OYSTER CREEK NUCLEAR GENERATING STATION

AMENDMENT TO PROVISIONAL OPERATING LICENSE

Amendment No. 124
License No. DPR-16

ATTACHMENT TO LICENSE AMENDMENT NO. 124

Fig. 3.2-1 Sodium Pentaborate Solution Volume - Concentration Requirement

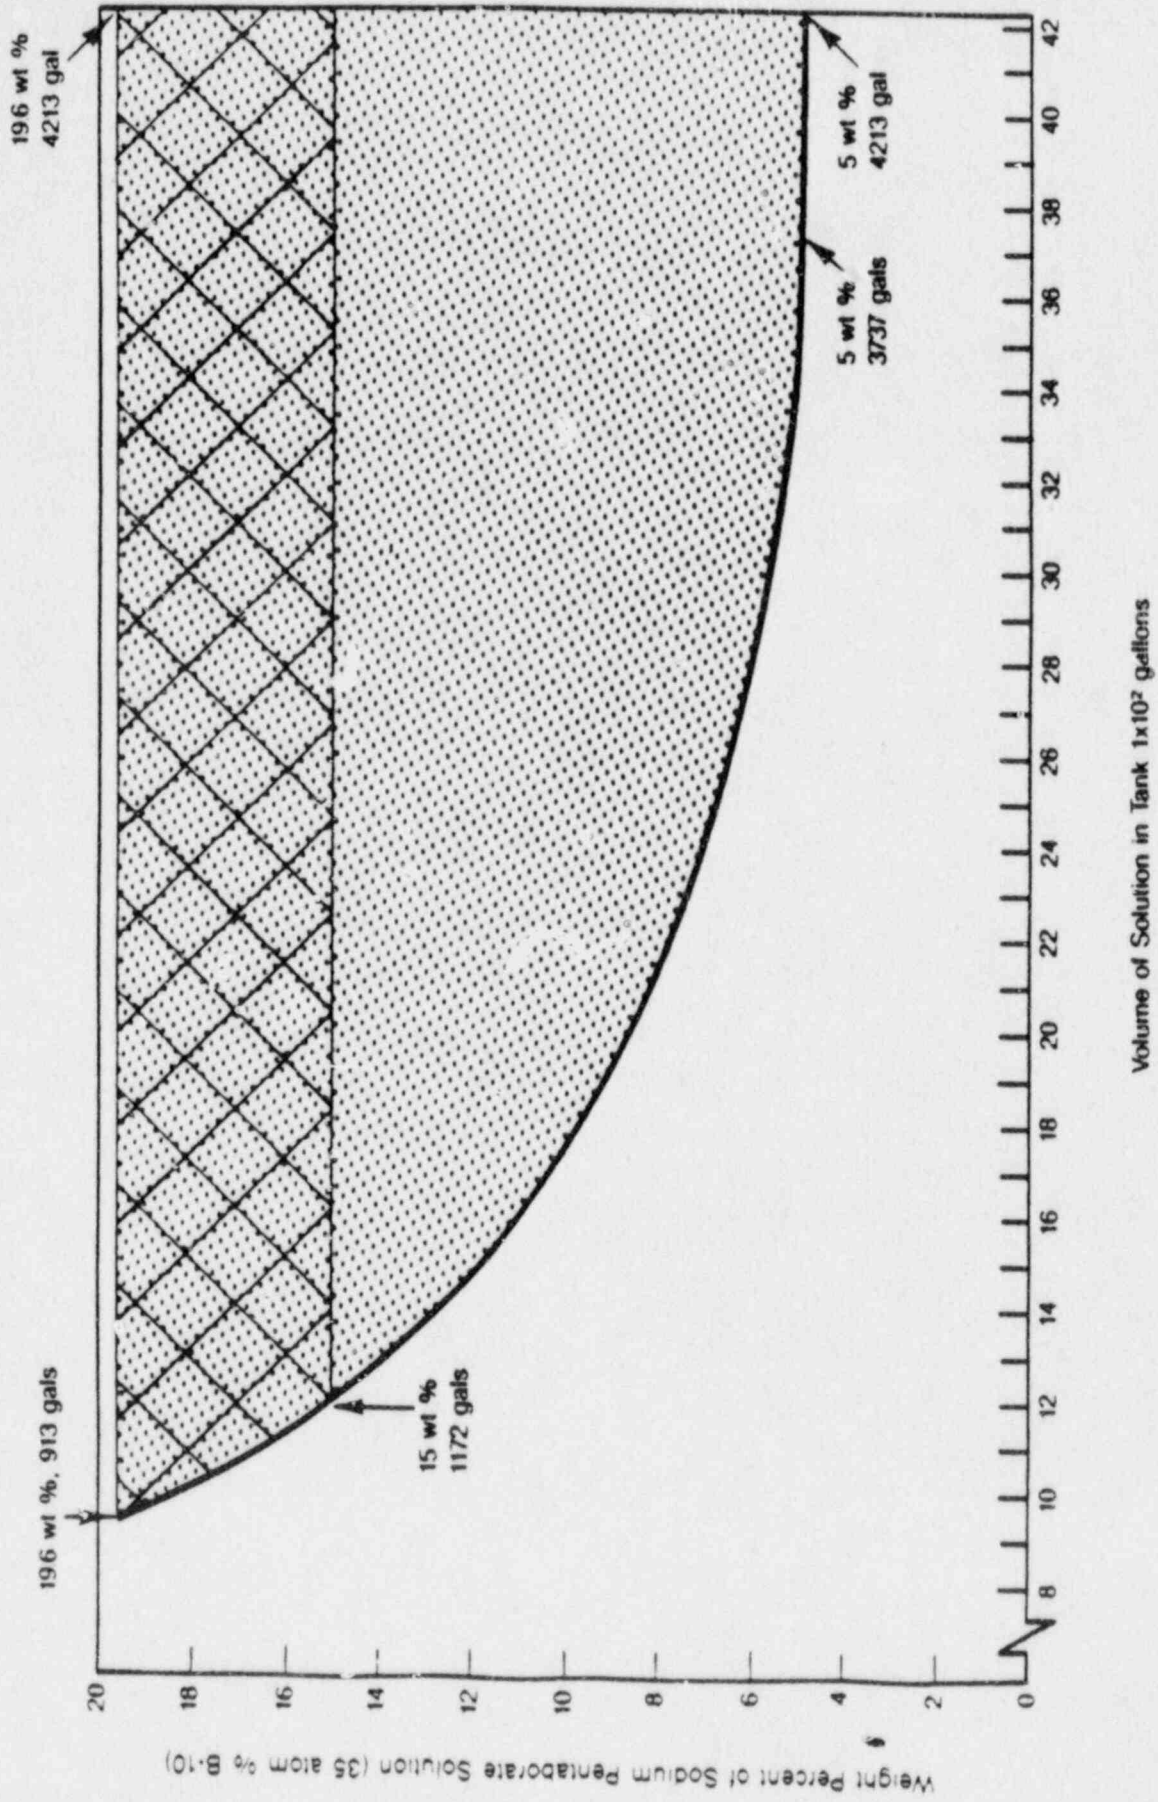
2. The standby liquid control solution shall have a Boron-10 isotopic enrichment equal to or greater than 35 atom %, be maintained within the crosshatched volume-concentration requirement area in Figure 3.2-1 and at a temperature not less than the temperature presented in Figure 3.2-2 at all times when the standby liquid control system is required to be operable.

- (b) If the solution is outside the crosshatched volume-concentration area but within the shaded volume-concentration area of Figure 3.2-1, return the solution to the crosshatched area within 7 days. If after this time period the requirement is still not met, submit a report to the NRC within 7 days advising them of plans to return the solution to the crosshatched volume-concentration area.

- (c) If the solution is outside the crosshatched volume concentration area and outside the shaded volume-concentration area of Figure 3.2-1, return the solution to within the shaded volume-concentration area of Figure 3.2-1 or be in the Shutdown condition within 24 hours.

Because Figure 3.2.1 has been revised to reflect the increased Boron-10 isotopic enrichment, an additional requirement has been added to evaluate the solution's capability to meet the original design shutdown criteria whenever the Boron-10 enrichment requirement is not met.

The shaded area of Figure 3.2-1 represents the acceptable values of liquid control tank volume and solution concentration which assure that, with one 30 gpm liquid control pump, the reactor can be brought to the cold shutdown condition from a full power steady state operating condition at any time in core life independent of the control rod system capabilities. The crosshatched area of Figure 3.2-1 represents the acceptable values of liquid control tank volume and solution concentration which assure that the equivalency requirements of 10CFR50.62 are satisfied. The maximum volume of 4213 gal is established by the tank capacity. The tank volume requirements include consideration for 137 gal of solution which is contained below the joint where the pump takes suction from the tank and, therefore, cannot be inserted into the reactor.

FIGURE 3.2.2 - Sodium Pentaborate Solution Temperature Requirements

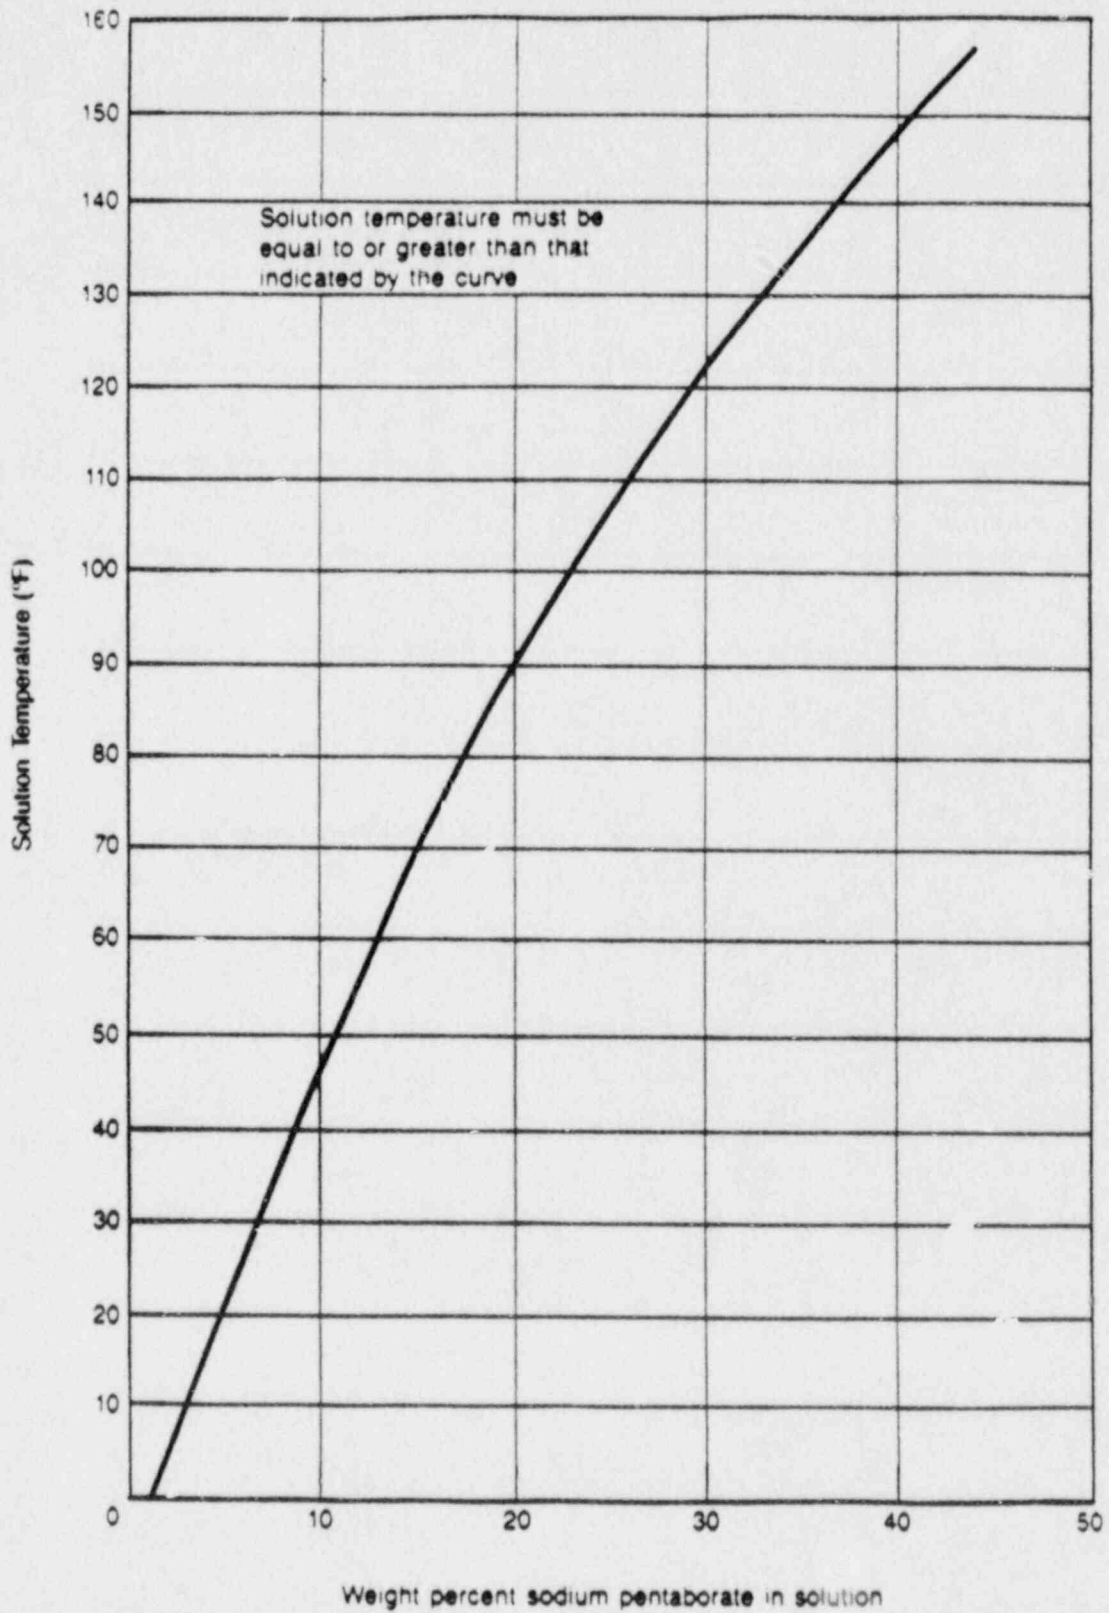
- (d) If the solution temperature is less than the minimum shown in Figure 3.2-2, increase the temperature to greater than the minimum and verify the solution is within the shaded volume-concentration area of Figure 3.2-1 or be in the Shutdown condition within 24 hours.

The solution saturation temperature varies with the concentration of sodium pentaborate. The solution will be maintained at least 5°F above the saturation temperature to guard against precipitation. The 5°F margin is included in Figure 3.2-2. Temperature and liquid level alarms for the system are annunciated in the control room.
